CANYONS SOUTH FILING NO. 3
PROPOSED SANITARY SEWER AND WATER PLANS
SITUATED IN PORTIONS OF SECTION 19 AND SECTION 30 IN TOWNSHIP 7 SOUTH,
RANGE 66 WEST OF THE 6TH PRINCIPAL MERIDIAN,
COUNTY OF DOUGLAS, STATE OF COLORADO
PROJECT NUMER CD22-0015

FCO #	DATE	PURPOSE/DESCRIPTION
FCO22-0039	7/11/2022	1.5" IRRIGATION SERVICE RELOCATION

CANYONS SOUTH FILING NO. 3
SANITARY SEWER AND WATER PLANS
TITLE SHEET

CANYONS SOUTH FILING NO. 3
SANITARY SEWER AND WATER PLANS
OVERALL UTILITY PLAN

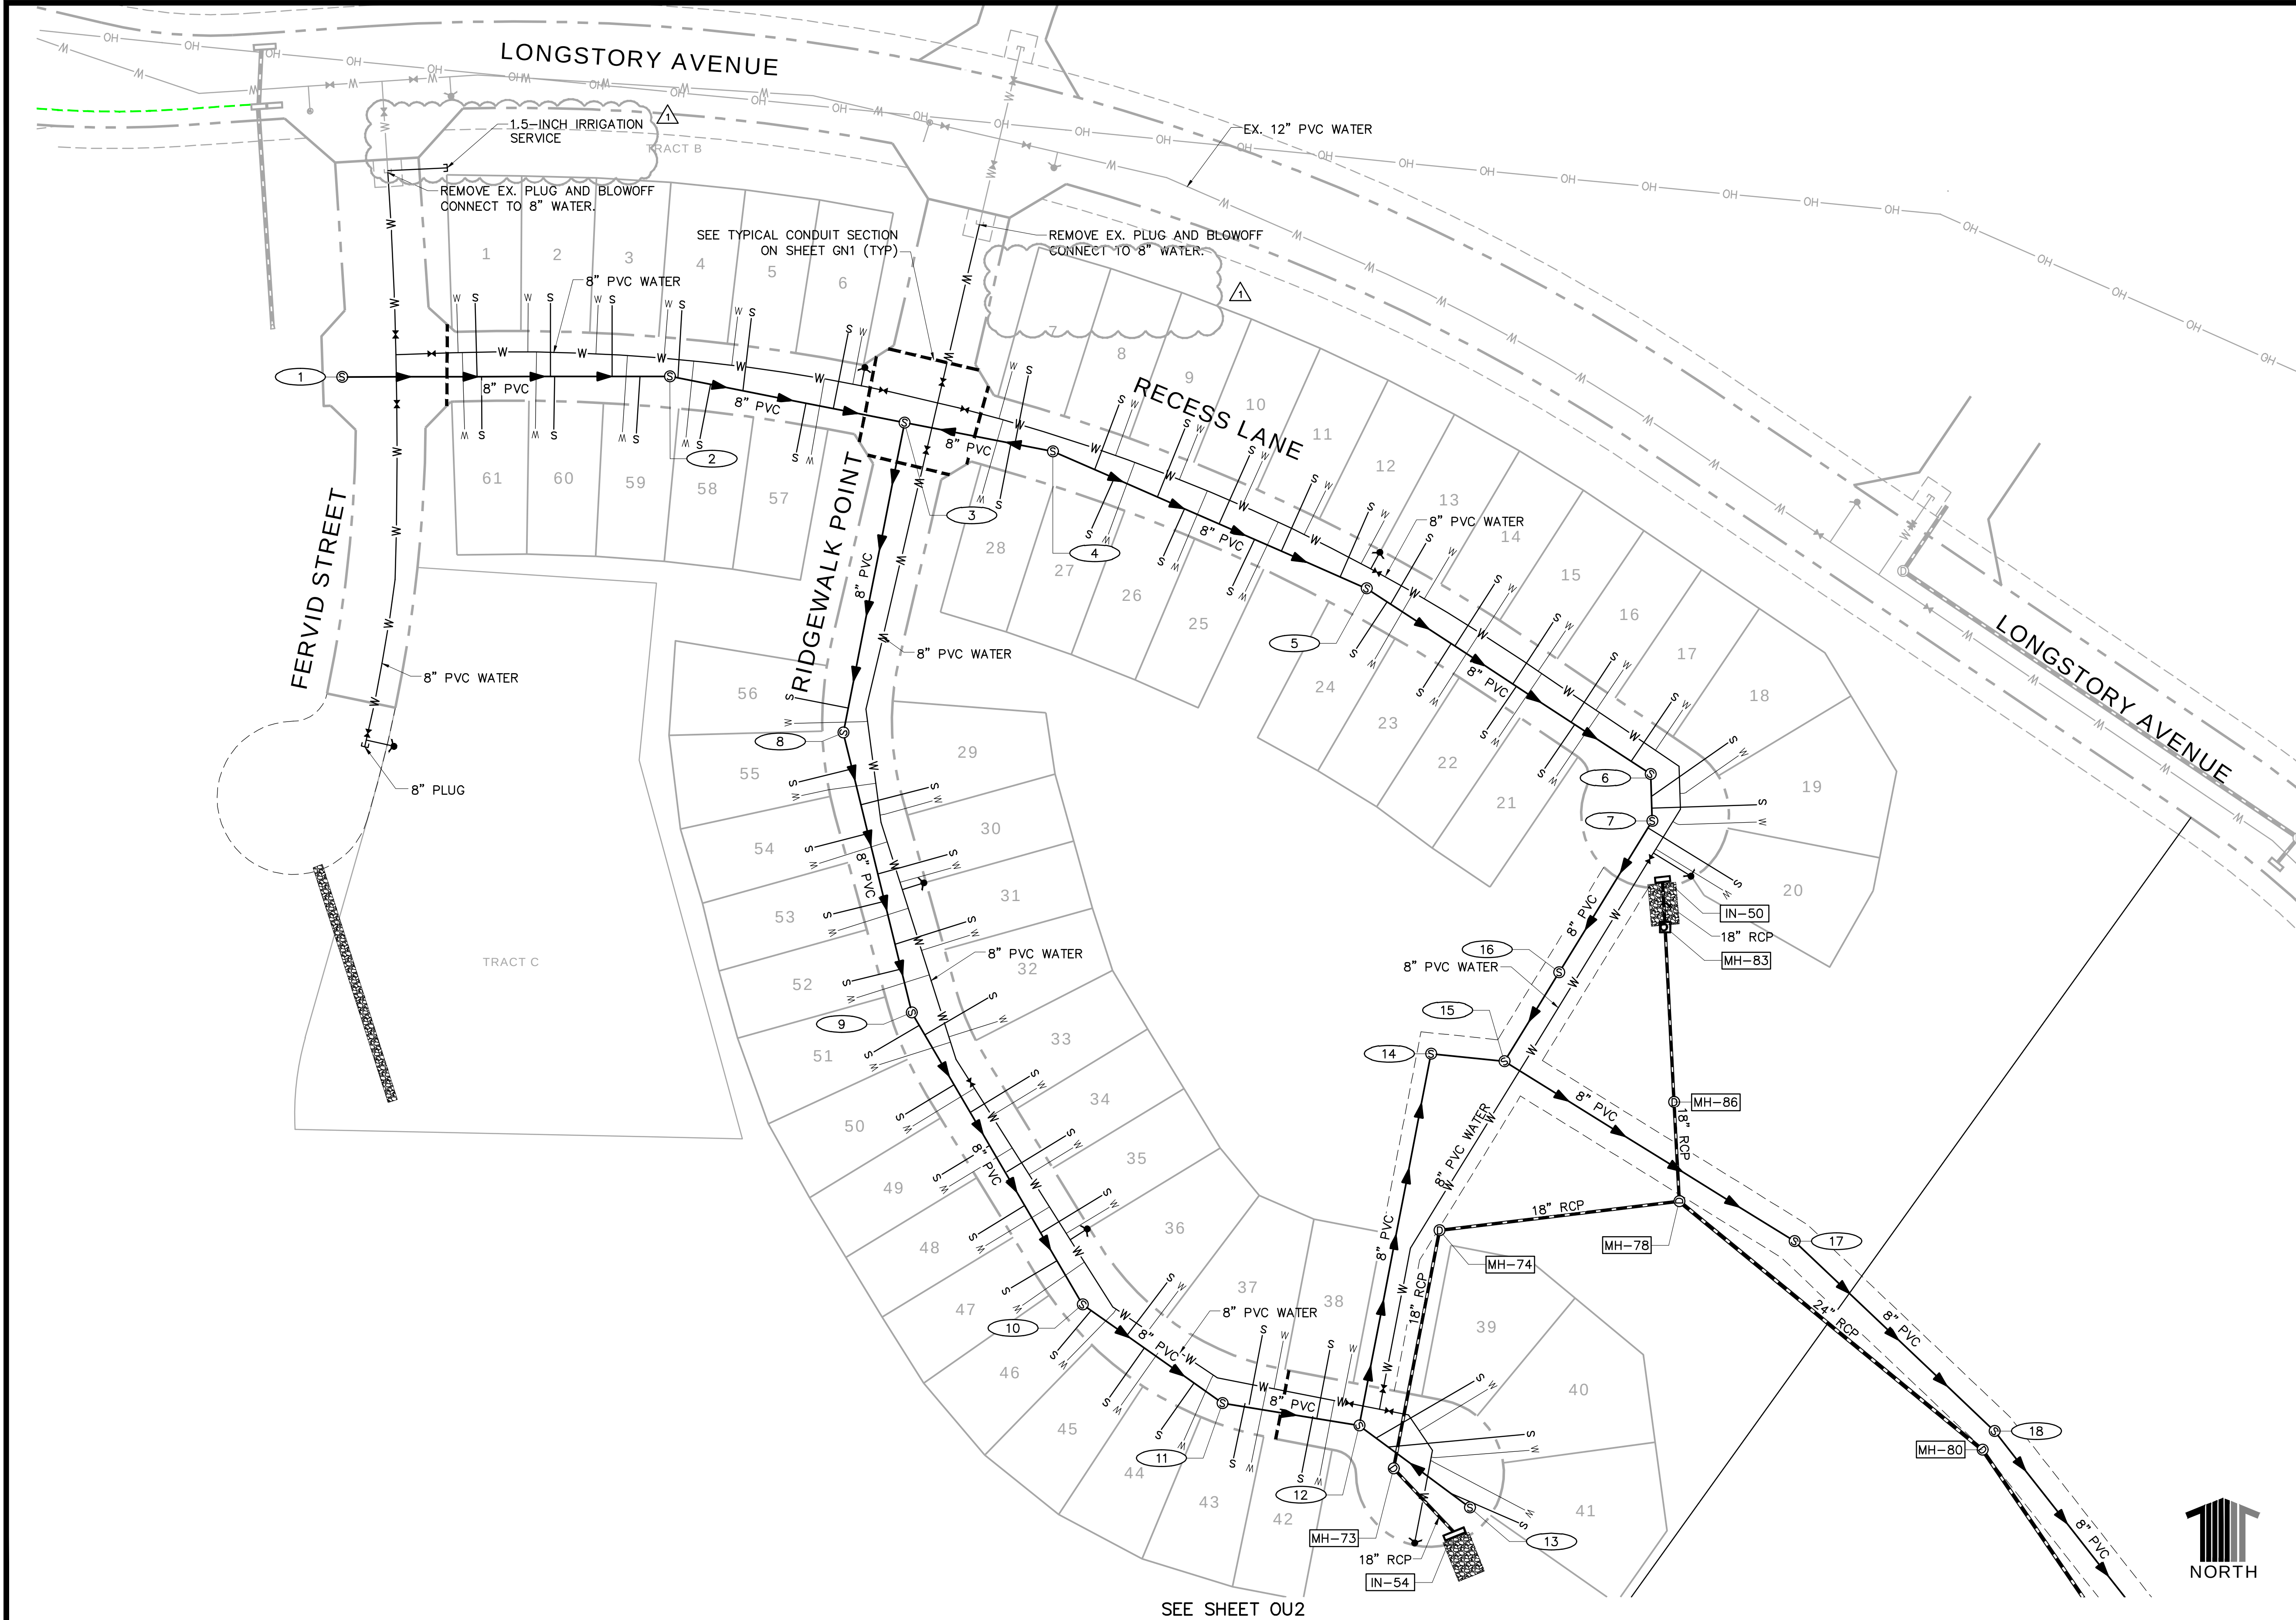
07/11/2022	RELOCATE 1.5" WATER SERVICE FCO22-0039
DATE	REVISION DESCRIPTION
